Submission to CSIRO's Draft 2024-25 GenCost Report

By Independent Engineers, Scientists and Professionals, 11 February 2025

Aim

Figure 3 Operational sent-out demand average time-of-day forecasts, summer and winter, Step Change, 2024-25 to 2049-50 (GW)

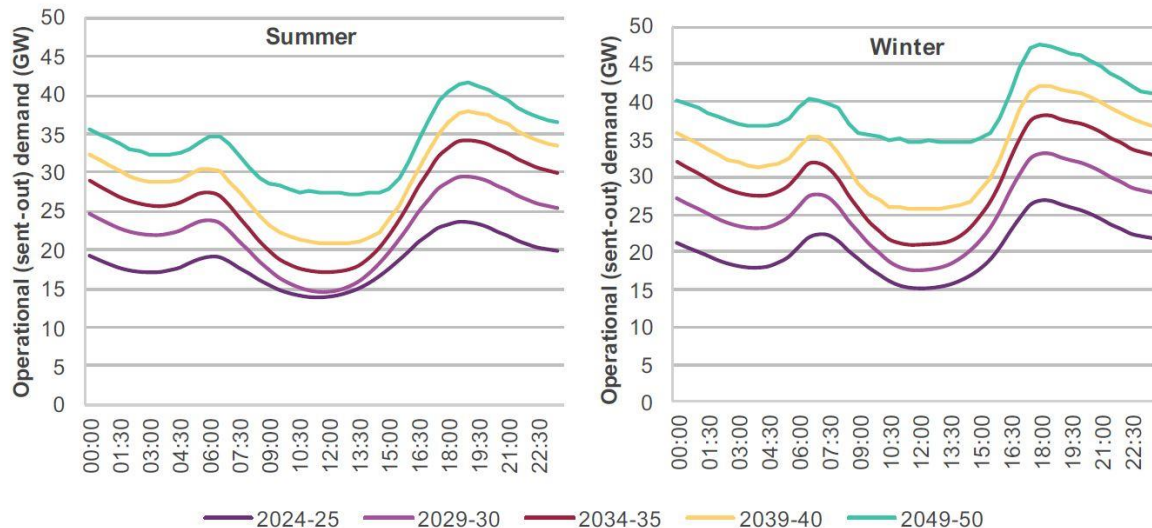
Figure 3 from the 2024 ISP Appendix 4 below illustrates the assumed daily profile projected into the future. By 2050, the peaks in early evening fall about 22% by early morning compared to about 30% currently.

ISP Appendix 4 speculates¹⁹ that **“The daily demand profile is forecast to change significantly by 2039-40, as a result of growth in..”** EV charging (which it suggests may be shifted to midday by time of use tariffs just when most people are likely to be needing their EV), electrification of home gas appliances, distributed PV system uptake and potential hydrogen production (and data centre demands). A great deal of uncertainty remains regarding future daily demand patterns, yet AEMO modelling incorporates this profile into its simulations of future grid performance.

Figure 2 Capacity, NEM (GW, 2009-10 to 2049-50, Step Change)

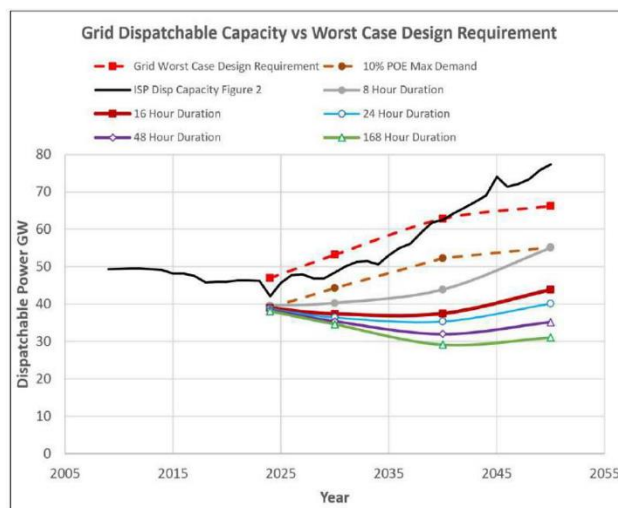
Figure 2 in the ISP is a graphical chart showing power from various generation sources and storages by year until 2050 (see next page).

It shows impressive growth to 2050 but almost all growth is in renewables, which have very low capacity factors (25-32%). Similarly, energy storage outputs show remarkable growth but most of these provide power for just a few hours. Much of it is from coordinated home resources which are uncertain and cost almost twice that for utility scale batteries. The dispatchable black line climbs to above 75 GW by 2050 but in truth, it is meaningless because much of it cannot be used to back up the grid when solar and wind power are largely absent for periods of 16 hours overnight, multiple days and significantly below average for periods of months.

This deceptive portrayal is merely a summation of maximum power outputs from all sources. A truthful depiction would, as a minimum include warnings to the effect that renewables provide less than one third of maximum power on average and not all dispatchable power provides practical levels for grid back up.

Figure 24 Operability through eight-day renewable drought, NEM except Queensland

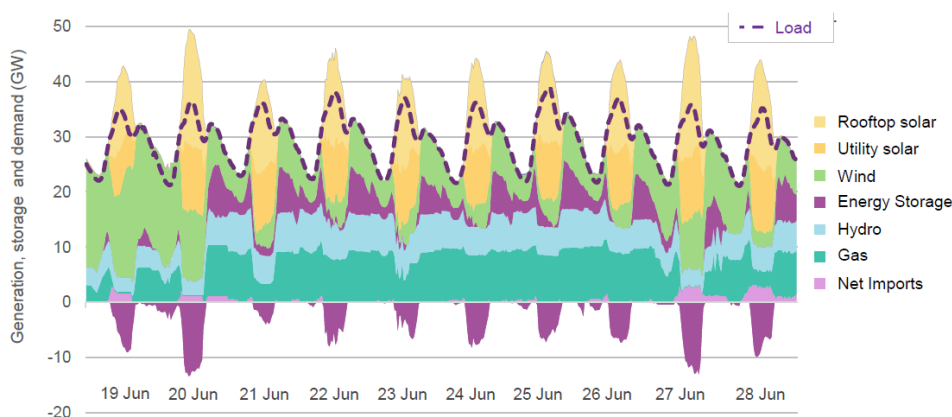
In the ISP, Figure 24 (p72) attempts to illustrate operability through an eight-day renewable drought for the “NEM except Queensland”. ISP Appendix 4 (Figure 15 p 26) reveals that this simulation test involved an “extended VRE drought event running from 21 June 2040 to 28 June 2040 (reflective of conditions observed historically in June 2019).”

This one-off test looks impressive but is merely an illustration far short of what a proper engineering analysis would require. A detailed examination of the data behind this test revealed the following:
